South – North Access Road

Stage 2 Road Safety Audit

Kilkenny County Council

September 2024

Figure 2.1 – Signs Placed Mid-Footpath Leading to Pedestrian Strikes

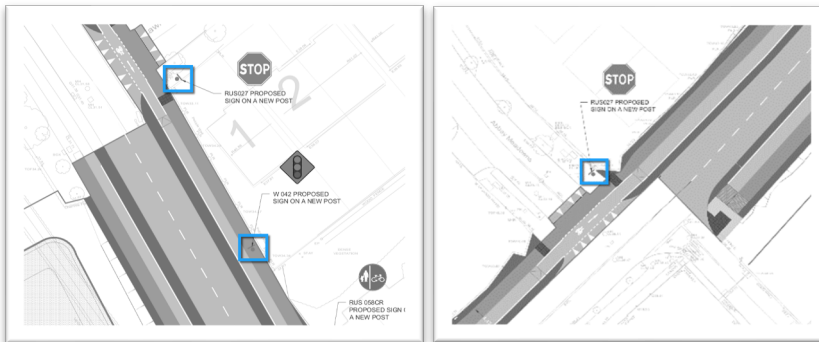
2.1 Problem: Signs / Signposts in Footpaths

Location: Various Sign Locations at Scheme Tie-Ins

Pedestrians (especially those who are blind or partially sighted) are likely to come into direct conflict with signs positioned within the footpath or at mid-footpath.

Signs should be positioned to the back of the footpath, at suitable locations where the risk of pedestrian strikes can be minimized.

Figure 2.3 – Tactile Paving Indicating Longer Crossings for Blind or Partially Sighted Person

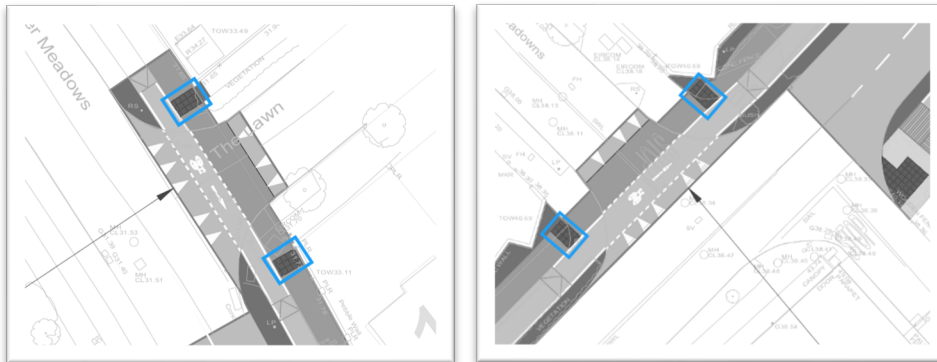
2.3 Problem: Tactile Paving May Confuse Blind / Partially Sighted

Location: Junction with The Lawn (North) & Junction with Abbeygate (South)

The tactile paving appears to be positioned to the rear of the footpaths. This may create confusion for blind or partially sighted road users, leading to poor decision making and conflicts with other road users.

The tactile paving should be re-positioned to the leading edge of the footpath, beside the interface with the adjacent traffic lane.

Figure 2.4 – Single Sided Tactile Paving Creating Confusion for Blind or Partially Sighted Person

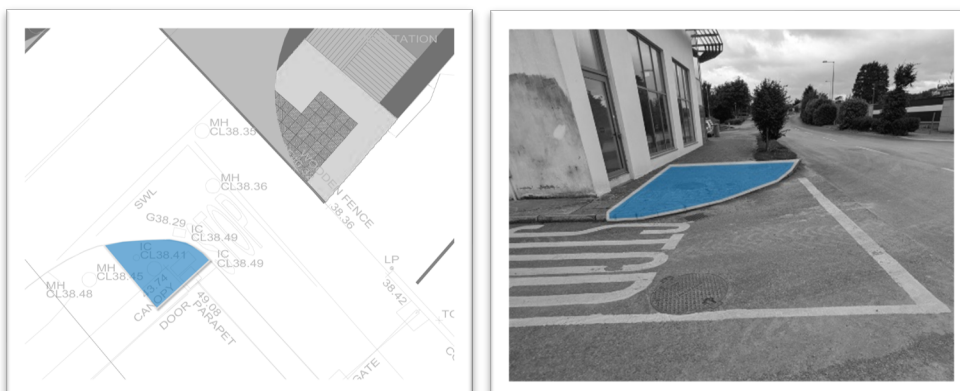
2.4 Problem: Single Sided Tactile Paving Set at Crossing

Location: Southern Scheme Tie-In – Service Road to Rear of Retail Units

Failing to provide an opposing set of tactile paving on the other side of the pedestrian crossing is likely to lead to confusion and progression issues for blind or partially sighted road users.

An opposing set of tactile paving should be provided on the other side of the pedestrian crossing.

Figure 2.5 – Planting Impacting on Operation of Road / Footpath & Cycletrack

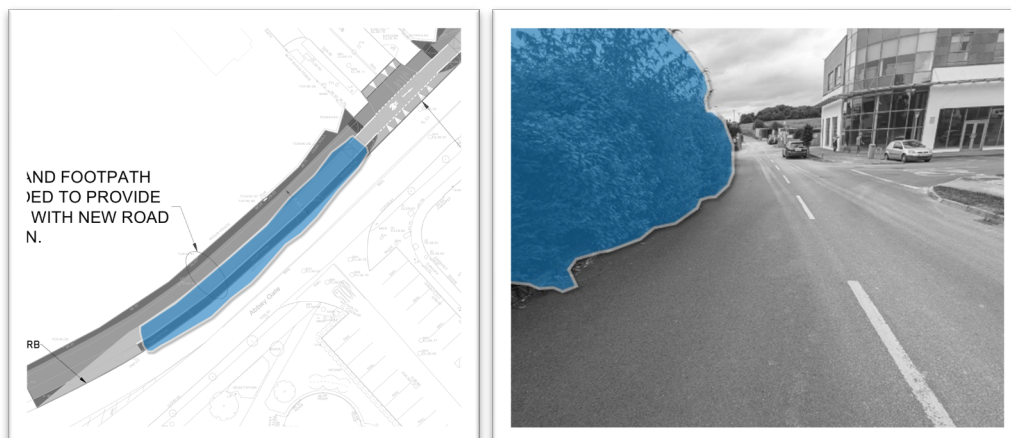
2.5 Problem: Planting Impacting on Operation of Road

Location: Southern Scheme Tie-In – Commencement of Off-Road Cycle Track

The overgrown verge planting was observed to reduce the effective width of the existing cycle track and the adjacent traffic lane. It also obscured sightlines at the junction serving Abbeygate.

The overgrown verge planting should be removed.
